UN R26 (external projections)

Comments to document GRSG/2019/11

Current production radius analysis

Figure 0
Example of parts distribution

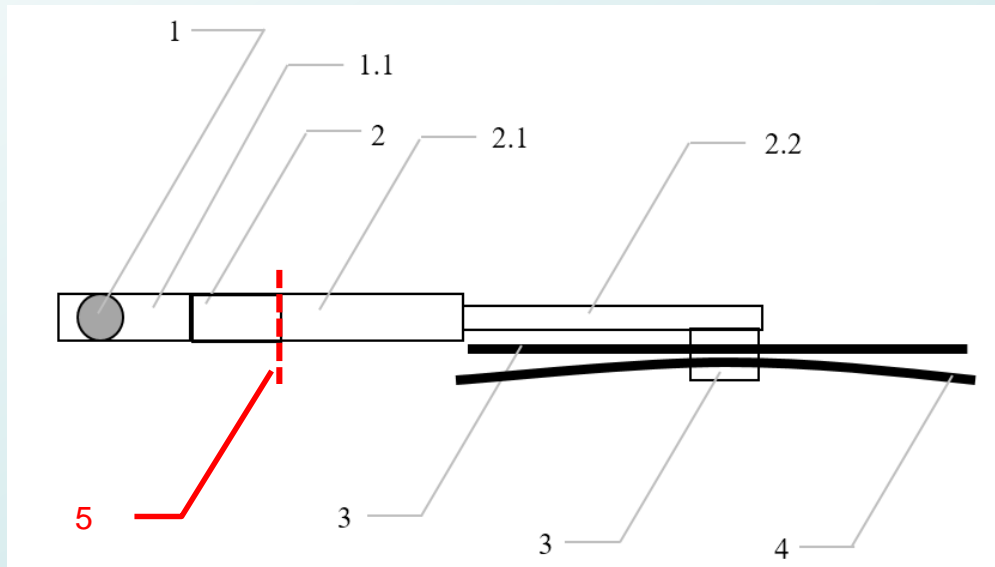
1. Red text is added to the French proposal by OICA as to overcome the problems with current wiper designs
2. The examples in the next slides show that part 2.1, part 2.2 and the functional hinge of current wiper designs do not meet the requirement of par. 5.4
3. Red text is added to the drawing by OICA to clarify the hinge location.

6.4.1. The windscreen wiper fittings shall be such that the wiper shaft (**number 1 in Figure 0**) is furnished with a protective casing (**number 1.1 in Figure 0**) which has a radius of curvature meeting the requirements of paragraph 5.4. above and an end surface area of not less than 150 mm². **The holder (head, ~~main and/or other parts~~, i.e. numbers 2, ~~2.1 and 2.2~~ in Figure 0) are designed with a radius of curvature meeting the requirements of paragraph 5.4. above.** In the case of rounded covers, these shall have a minimum projected area of 150 mm² when measured not more than 6.5 mm from the point projecting furthest. These requirements shall also be met by rear window wipers and headlamp wipers.

6.4.2. Paragraph 5.4. shall not apply to the wiper blades (**number 4 in Figure 0**), ~~or to any~~ supporting members (**number 3, 2.2, 2.1 in Figure 0**) **or to the functional hinge between the holder head and the holder (number 5 in figure 0).** However, these units shall be so made as to have no sharp angles or pointed or cutting parts.

Design A

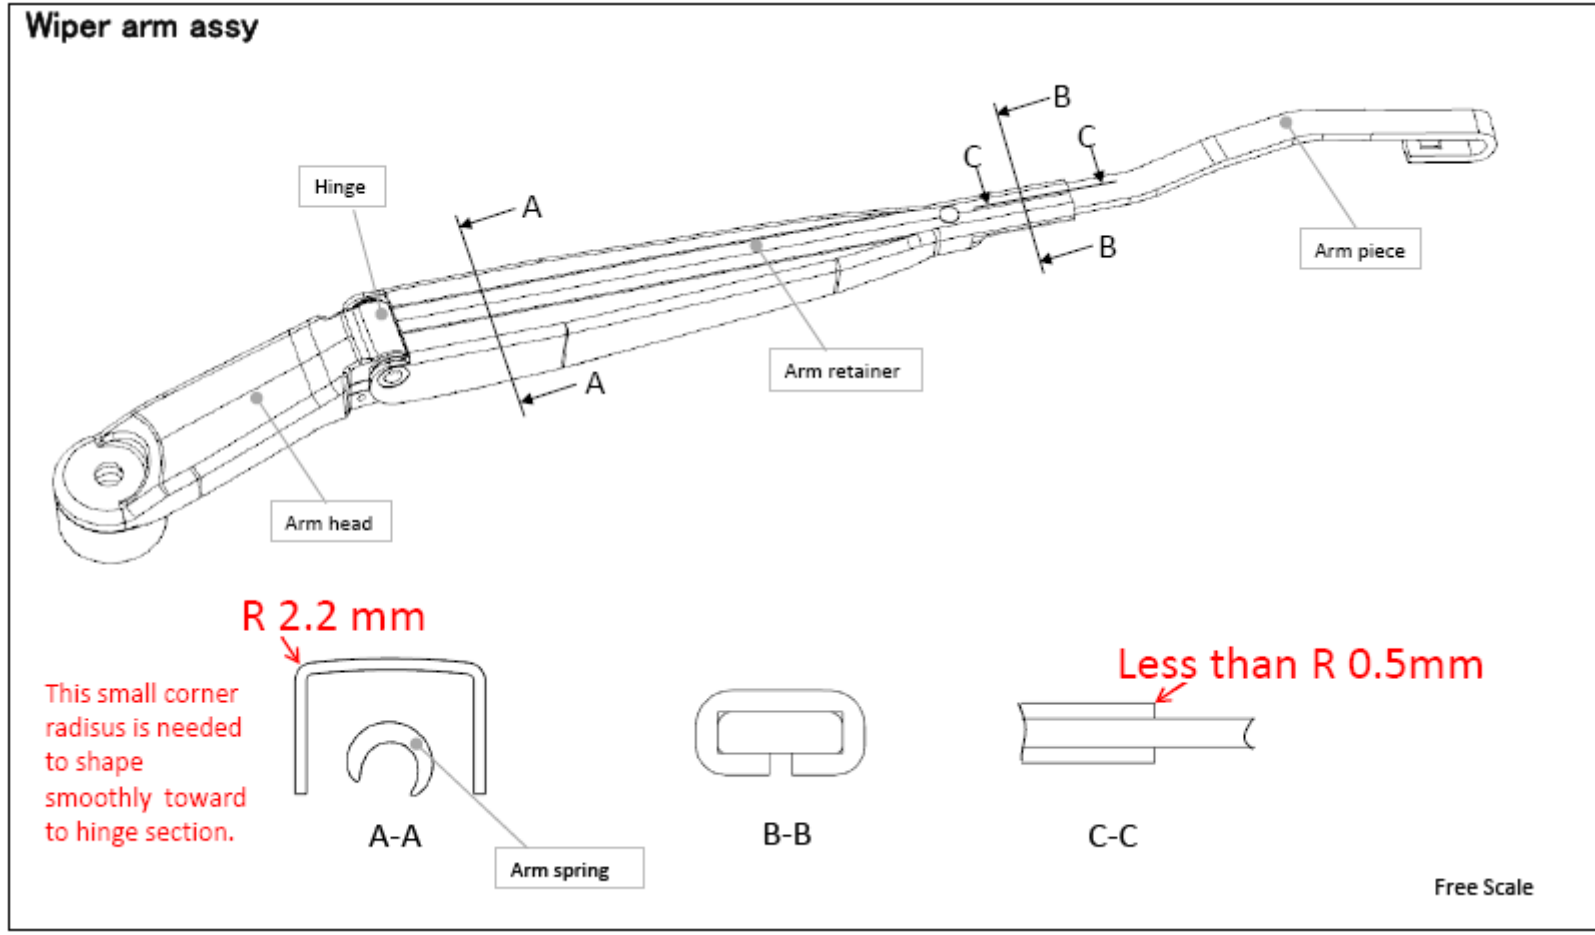
Since the subject part of paragraph 2.1 is made of metal with thickness of approx. 1.6 mm, it is impossible to secure radius of curvature at its end. It holds the subject part of para. 2.2. Significant design change is required to secure radius of curvature 2.5 mm at its folded part.

design C

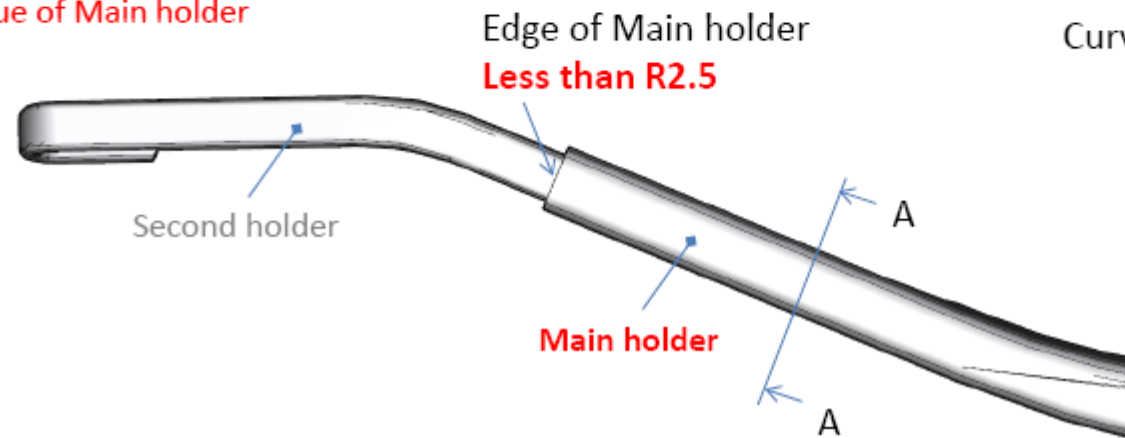
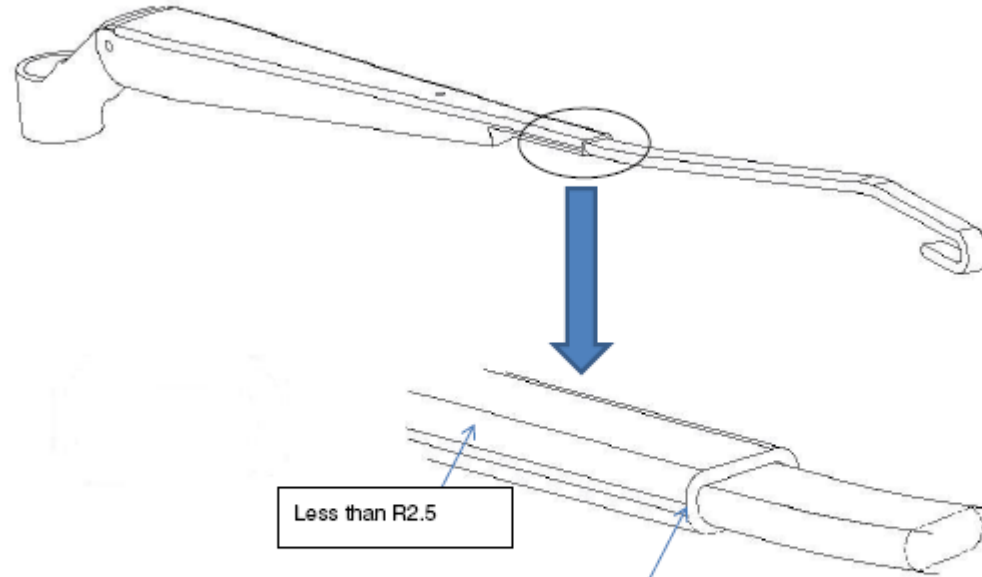
Issue of Main holder

Curvature of Main holder

Less than R2.5

The curvature changes gradually towards Functional hinge.

design D

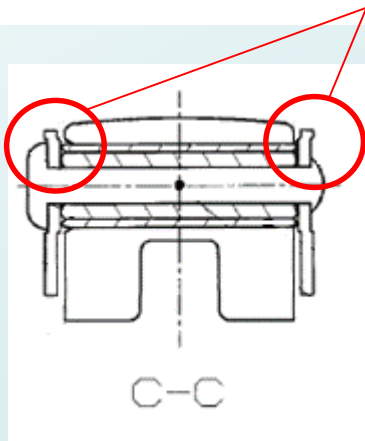
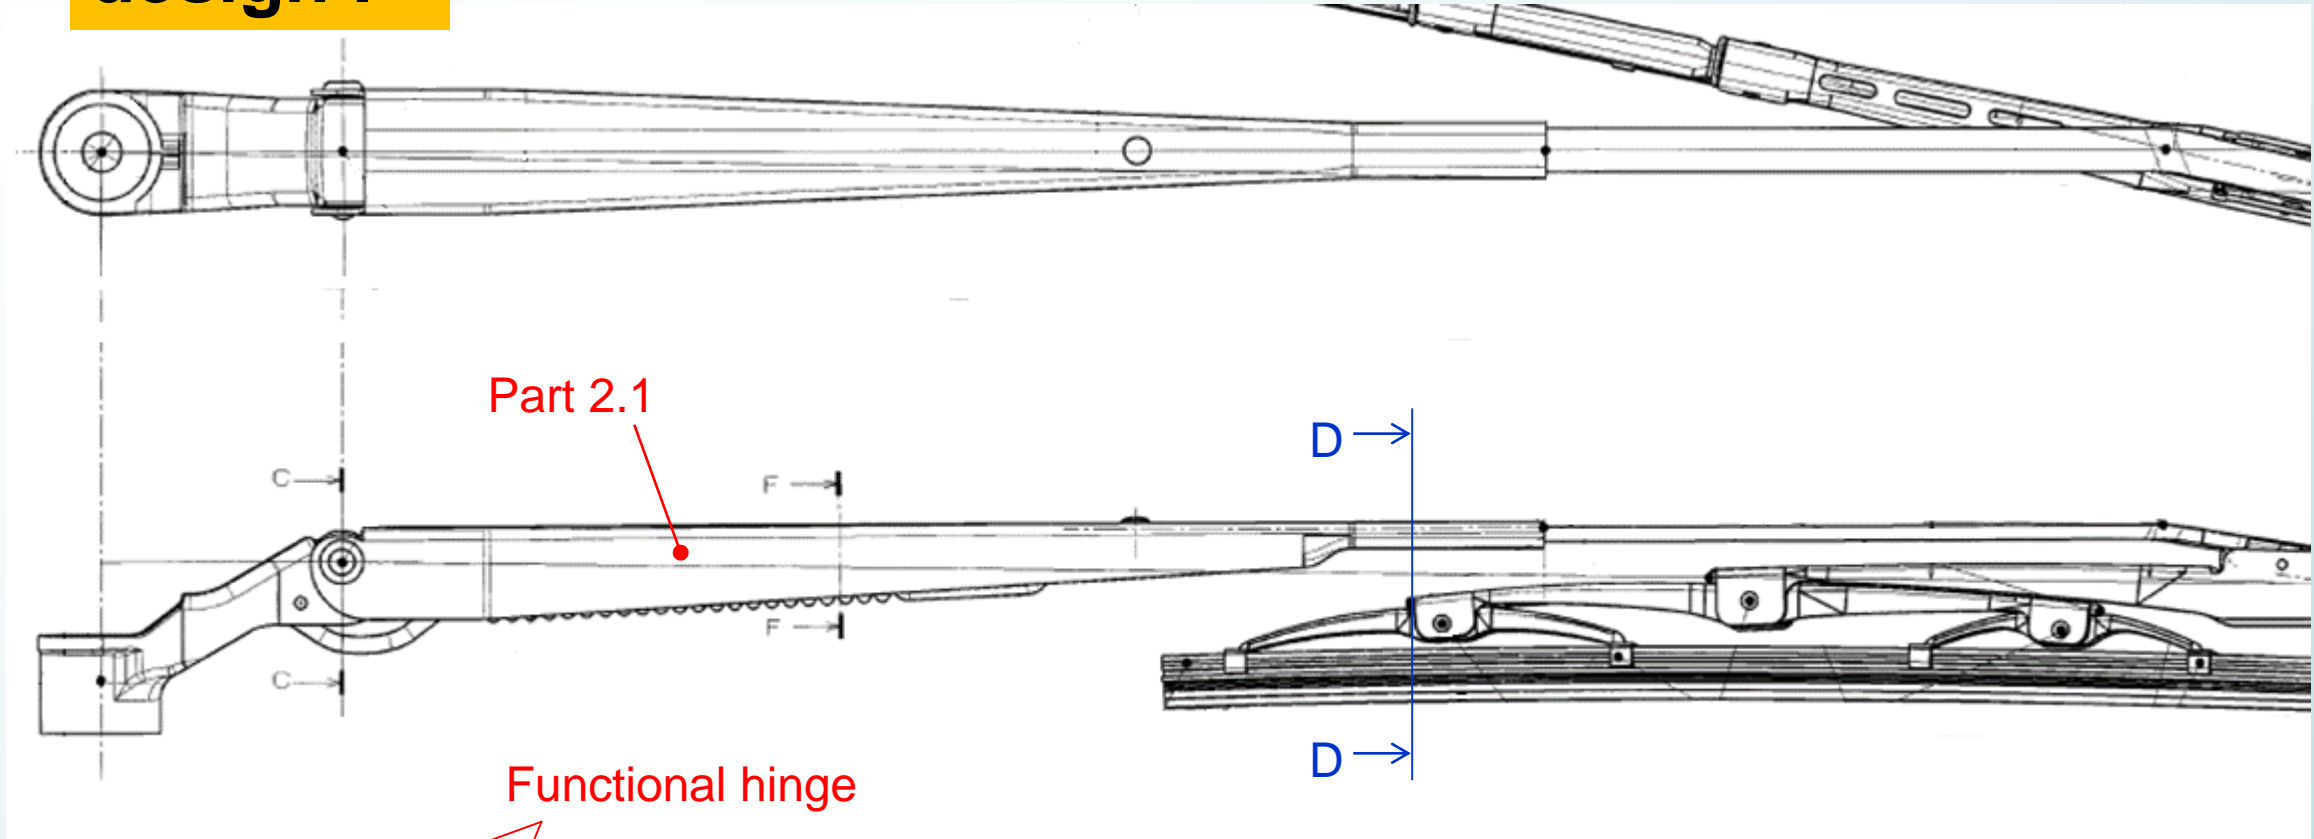
Less than R2.5

Less than R2.5

It's extremely difficult to meet R2.5 requirement for this part.

High possibility that 5.4 in UN R26 "This requirement shall not apply to parts of the external surface which protrude less than 5 mm" doesn't apply to this part

design F

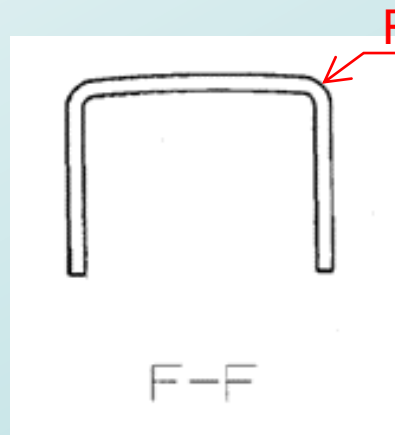
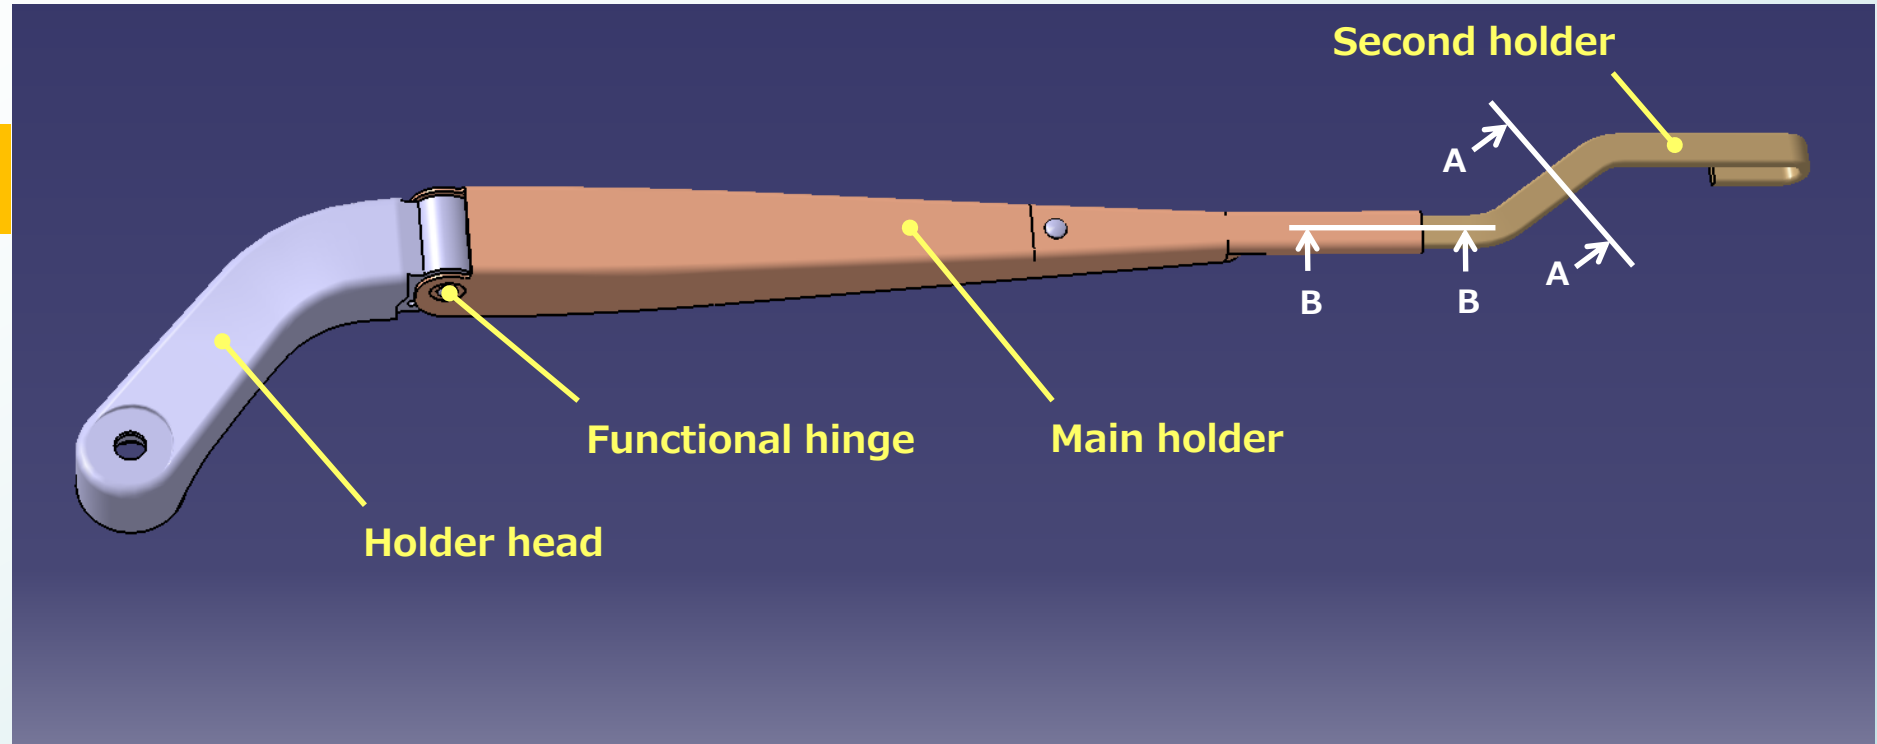
R2.1 ~ R4

R1.7 ~ R2.1

design G1

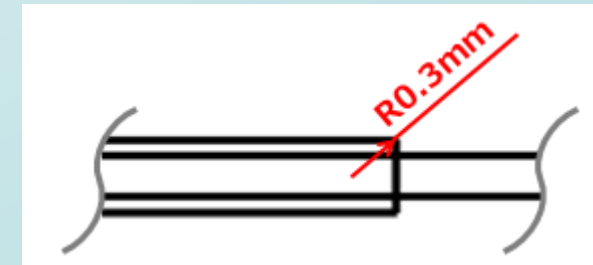
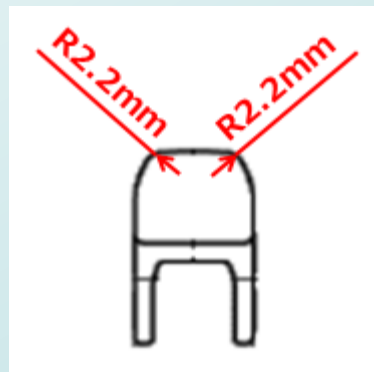
Curvature of second holder
less than R2.5mm

Edge of main holder
less than R2.5mm

design G2

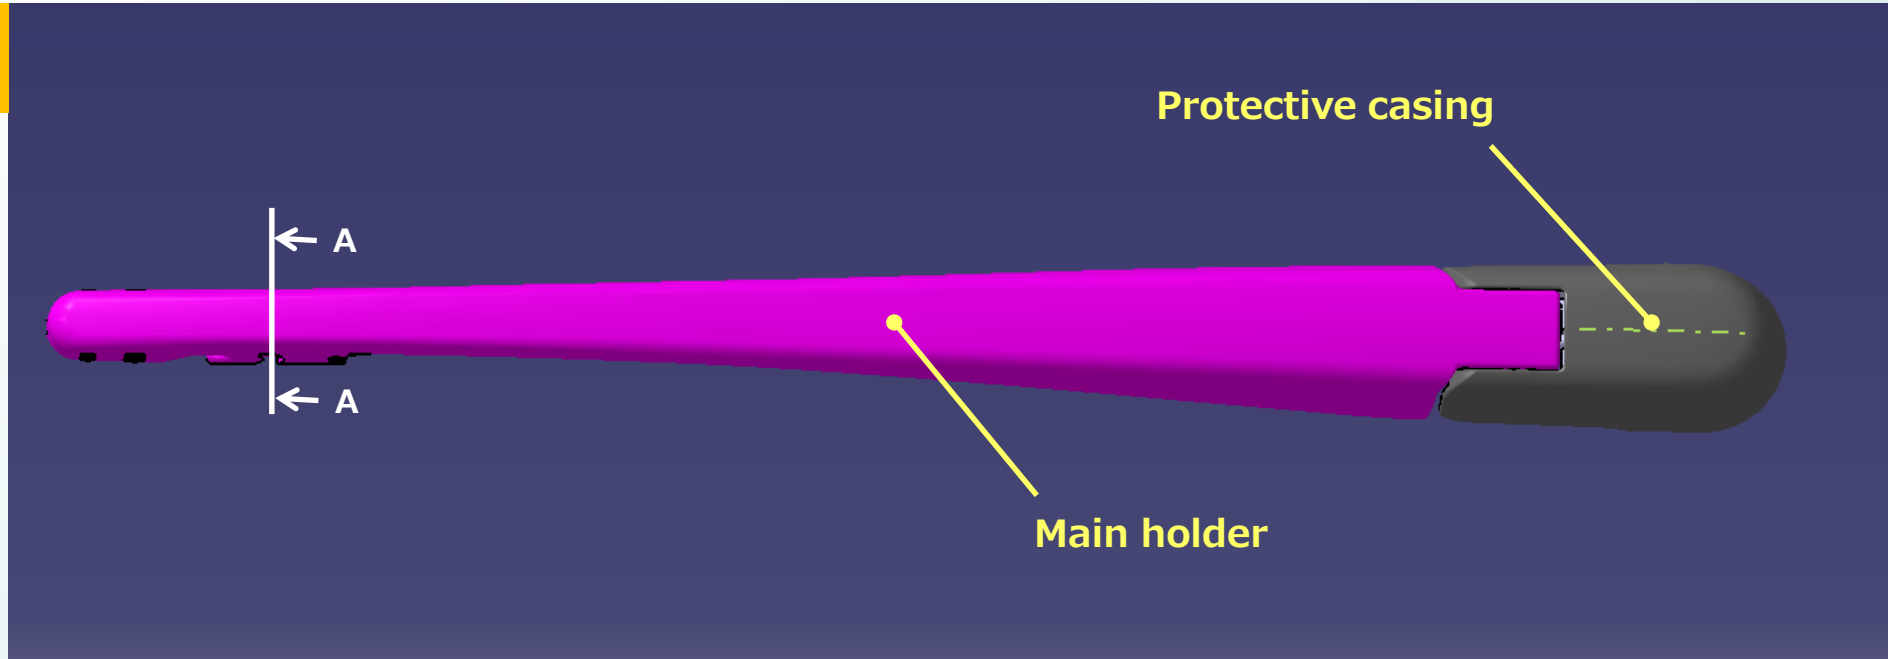
Curvature of main holder
less than R2.5mm

design G3

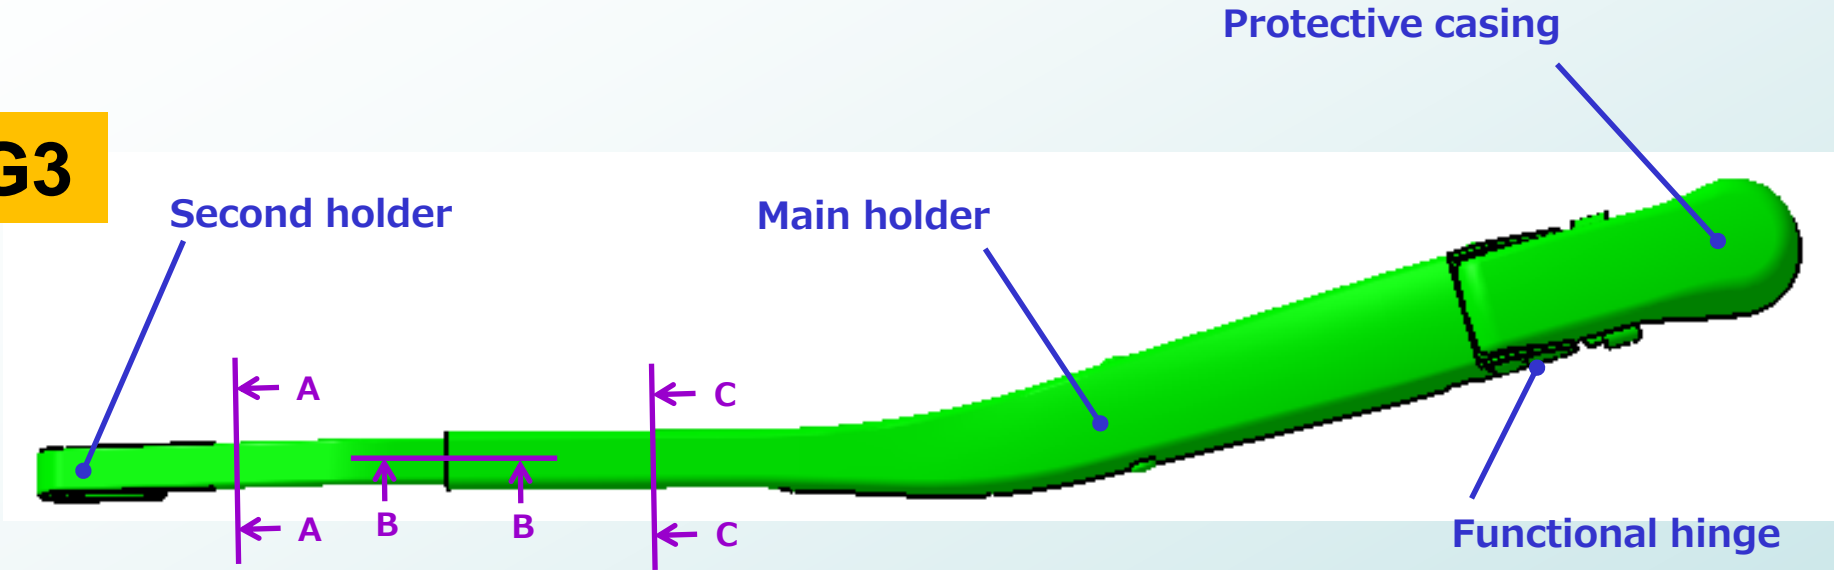
Curvature of second holder less than R2.5mm

Edge of main holder less than R2.5mm

Curvature of main holder less than R2.5mm

design H1

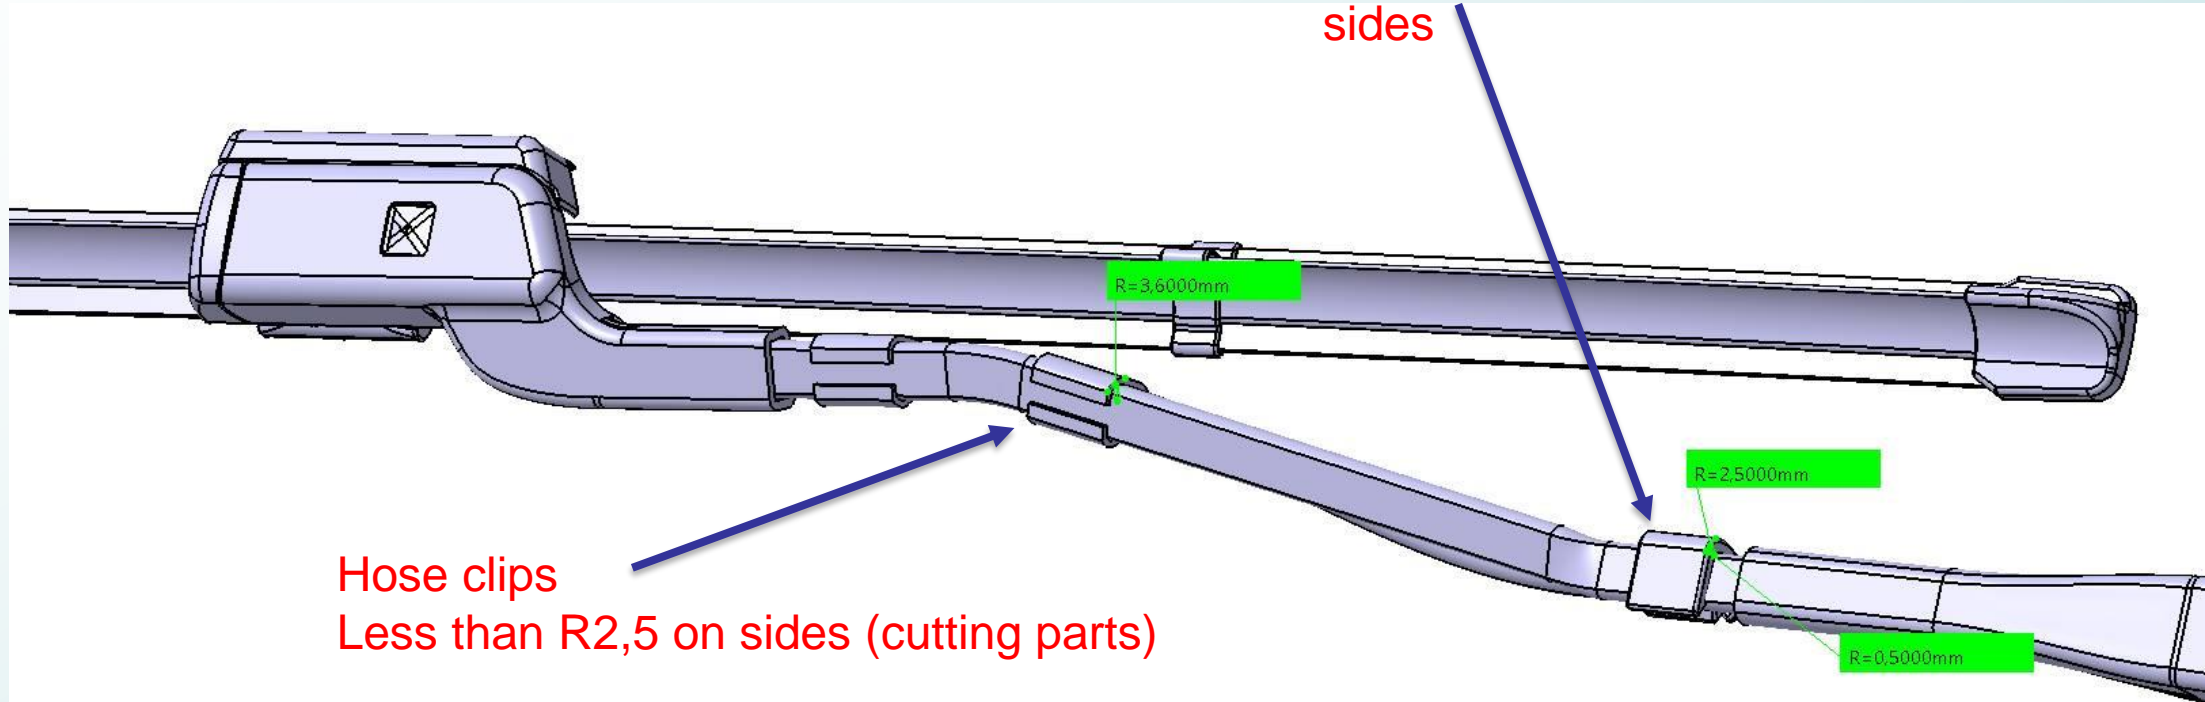
Cutting areas
Less than R2,5

Nozzle
Less than R2,5 on
sides

Hose clips
Less than R2,5 on sides (cutting parts)
